Town of Hilton Head Island

Design Review Board Meeting

Tuesday, September 10, 2024, 2:30 PM

**1014 William Hilton
Parkway
PLAN SET**

SHEET TITLE
Landscape Plan

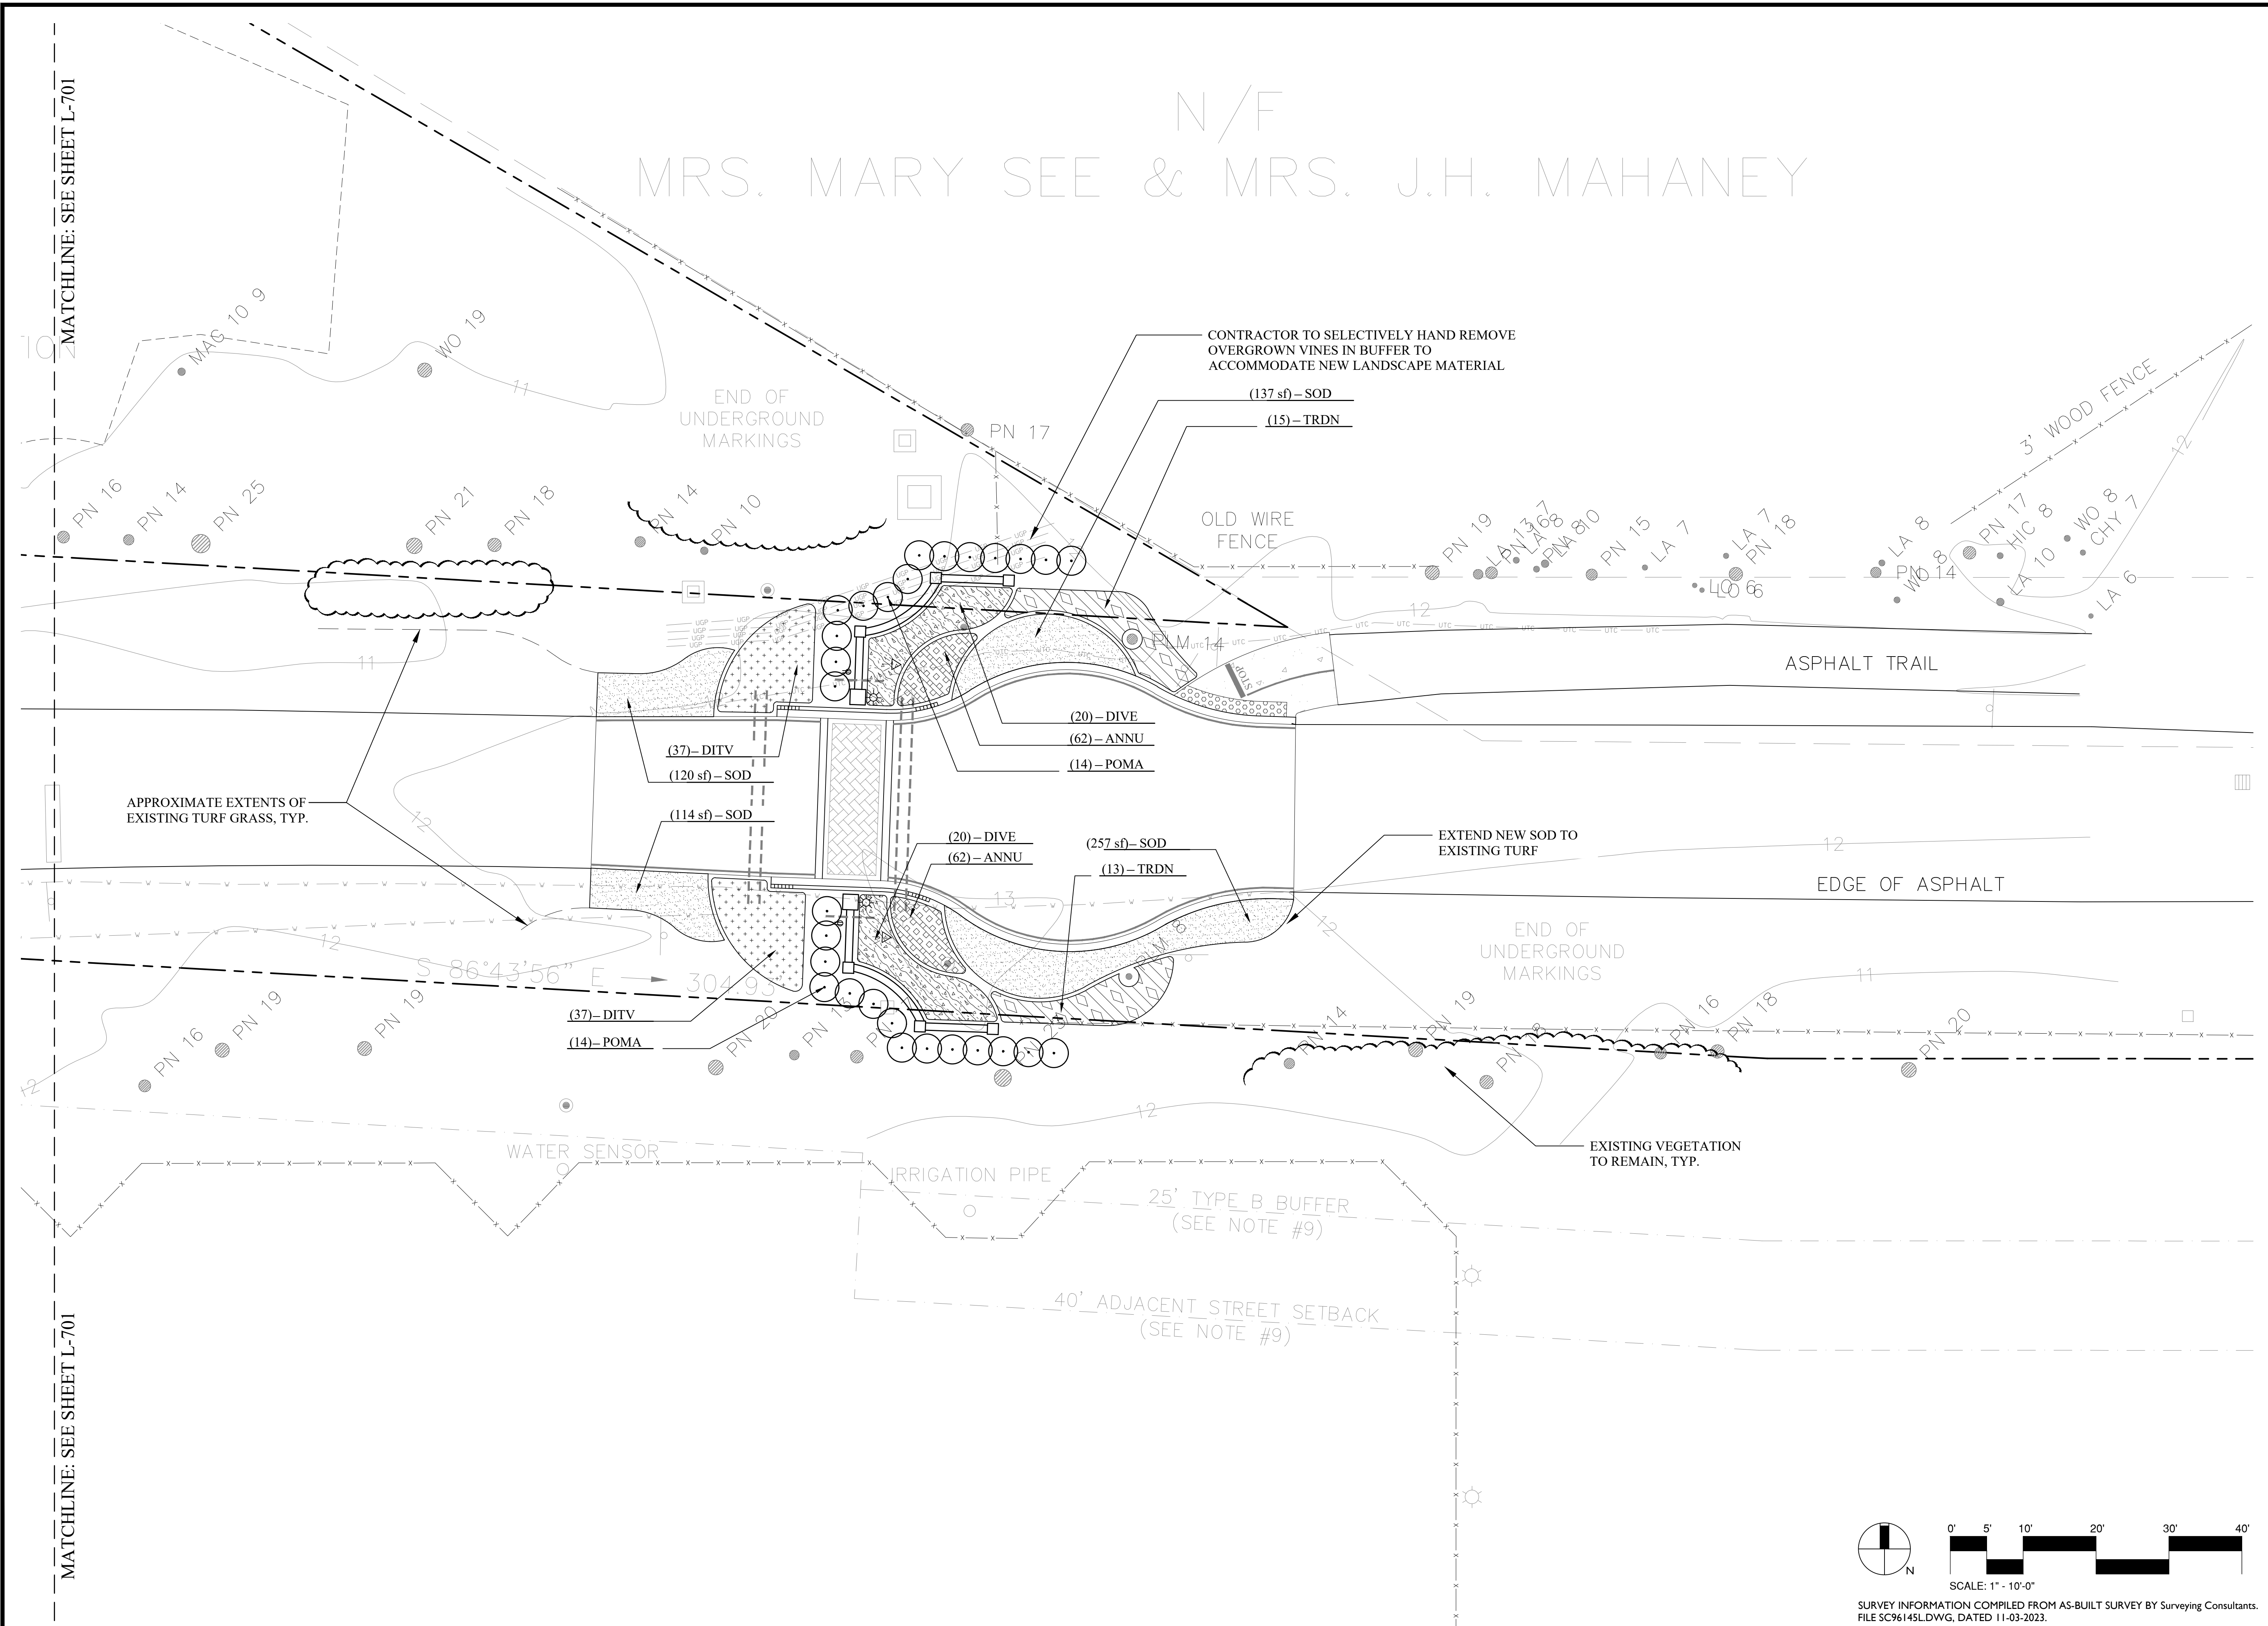
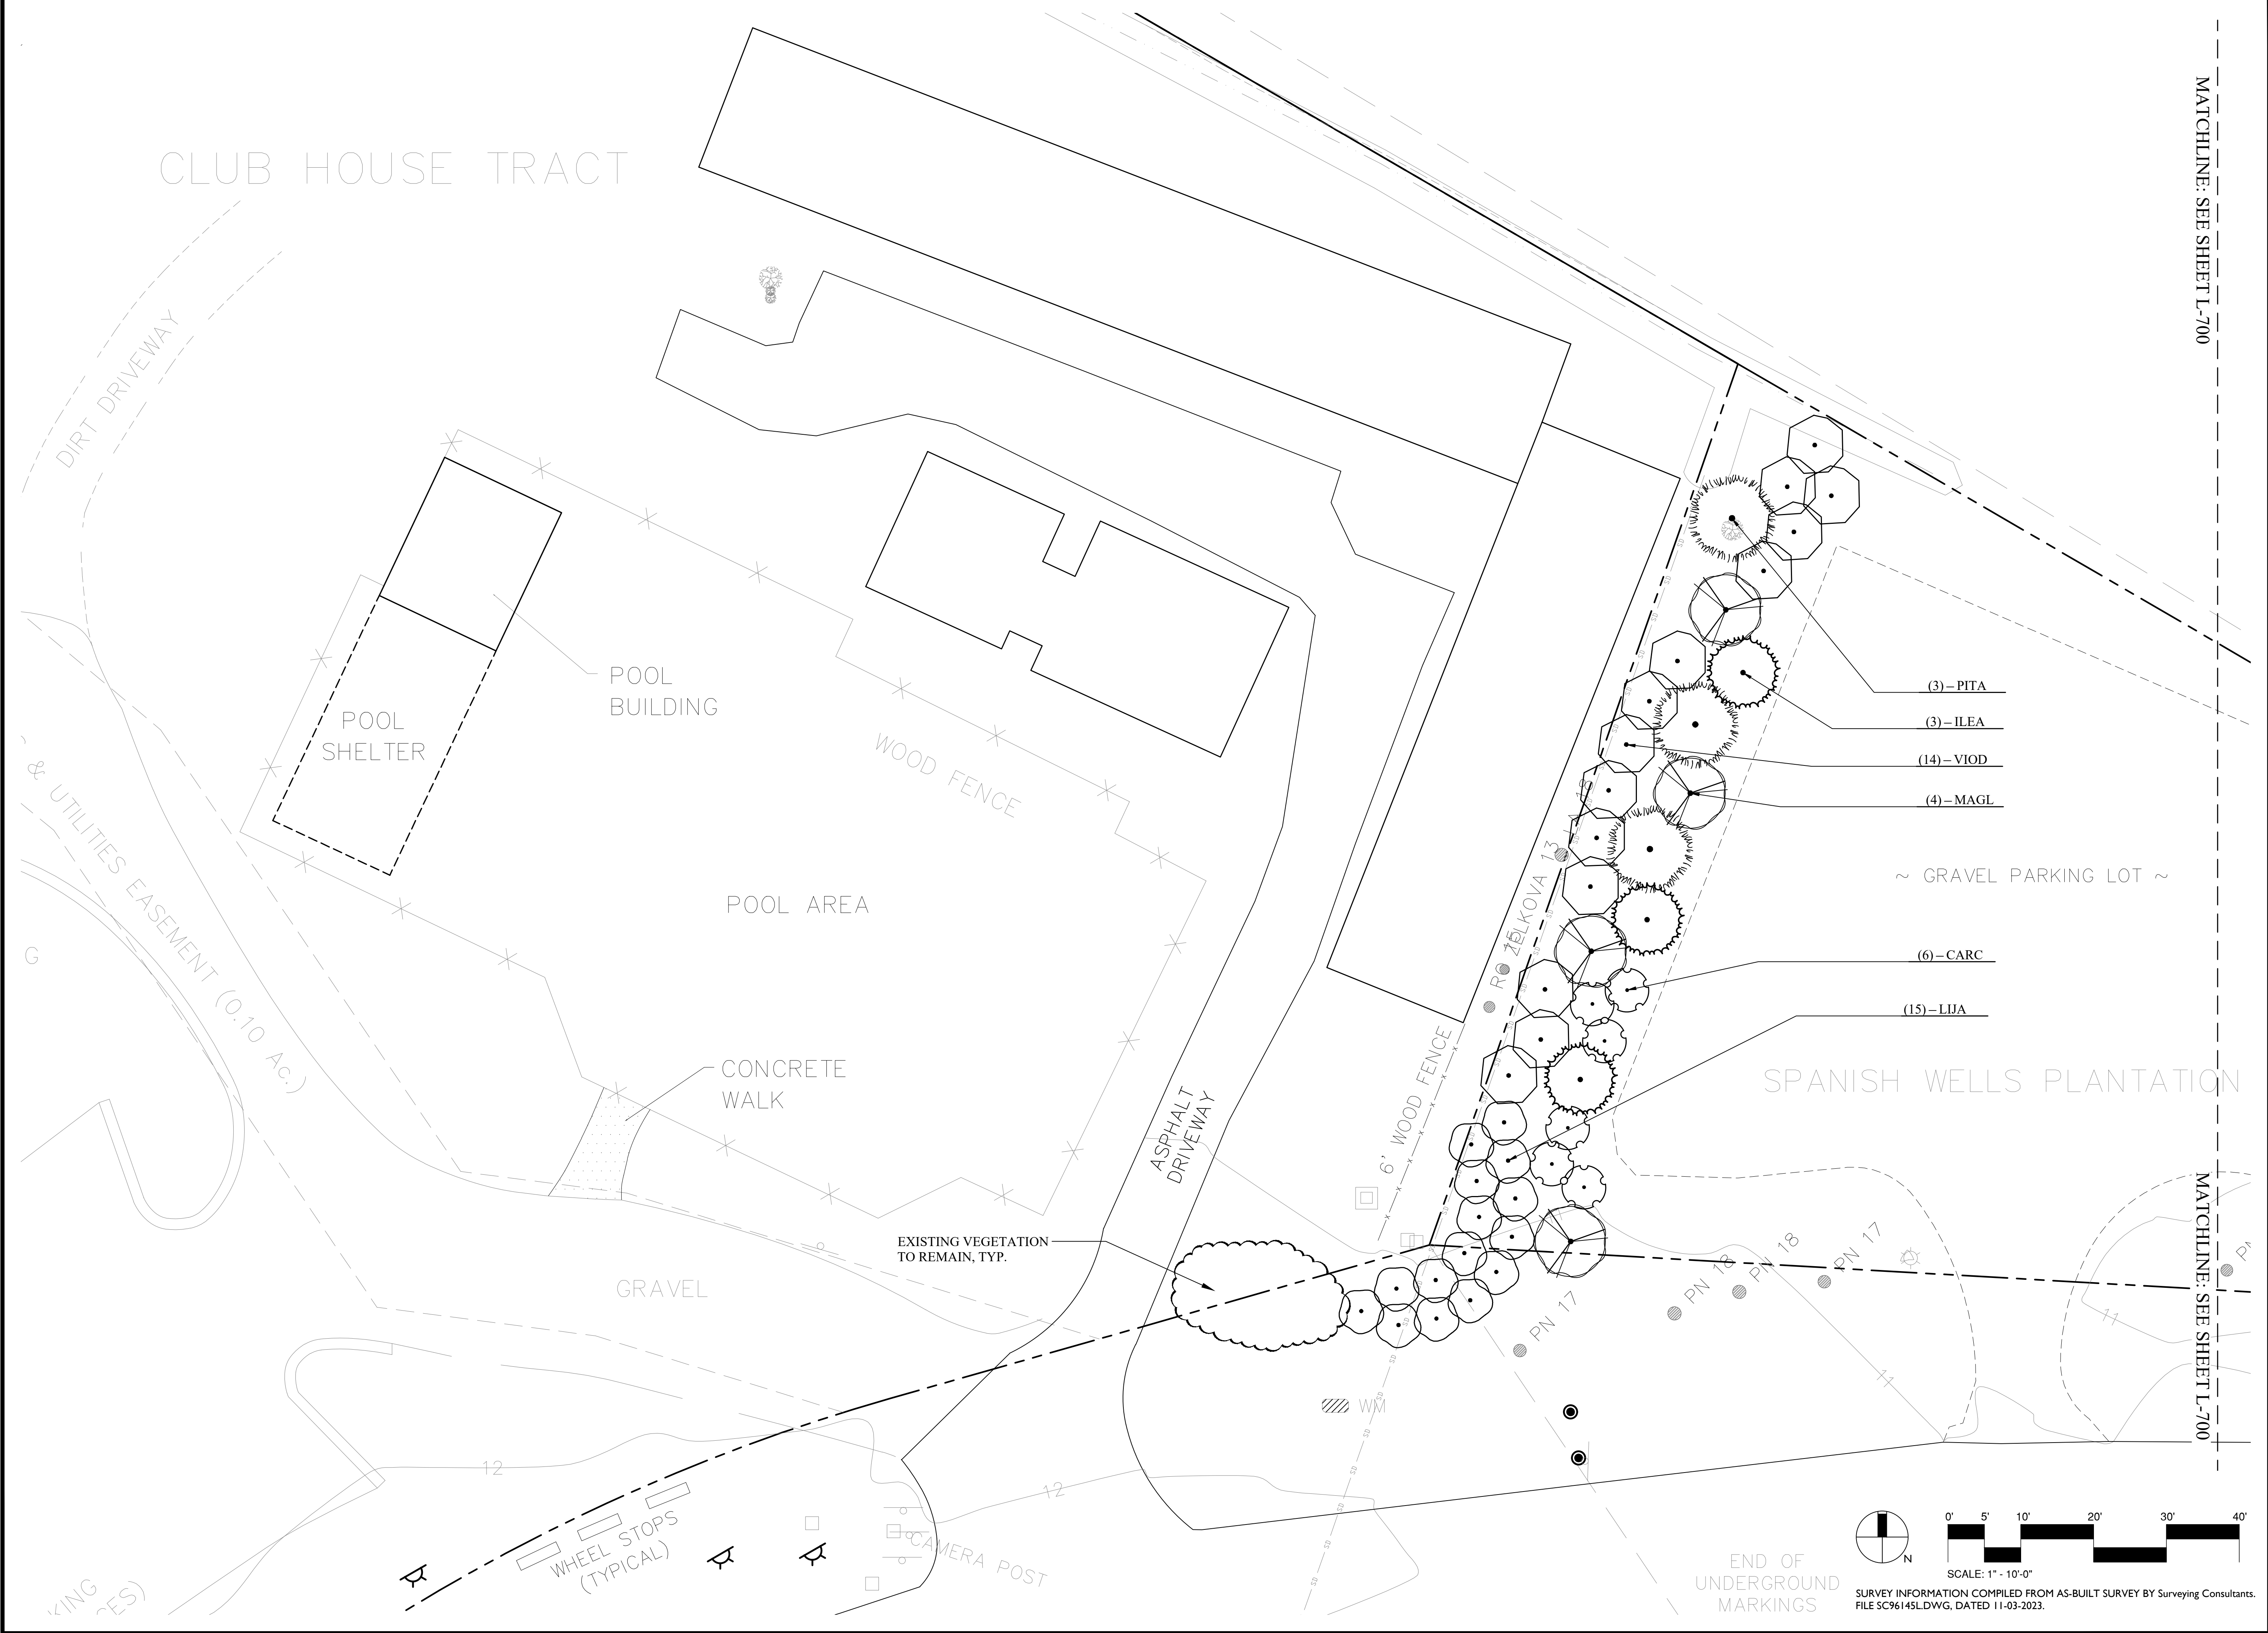
Mr. Parker made a motion to approve with the following conditions: incorporate staff comments, integrate the security camera into the design if possible to avoid exposed conduit, include landscaping along the backside of the side elements of the fence to provide full coverage, and review the plant selections to verify they are native species. Ms. Lippert seconded. The motion passed unanimously.

In response to comments received from the conceptual Design Review Board submittal, the landscape plan has been updated to include more native plant material. Proposed non-native material are adaptive plants commonly found on the island that are in keeping with island character and appropriate for high touch areas. Additional landscaping has also been added behind the pierced brick wall per DRB feedback. The existing security cameras are to be removed and will not be reintegrated into the sign, columns or walls. If ownership decides to add cameras at the entry they will be installed in the landscape.
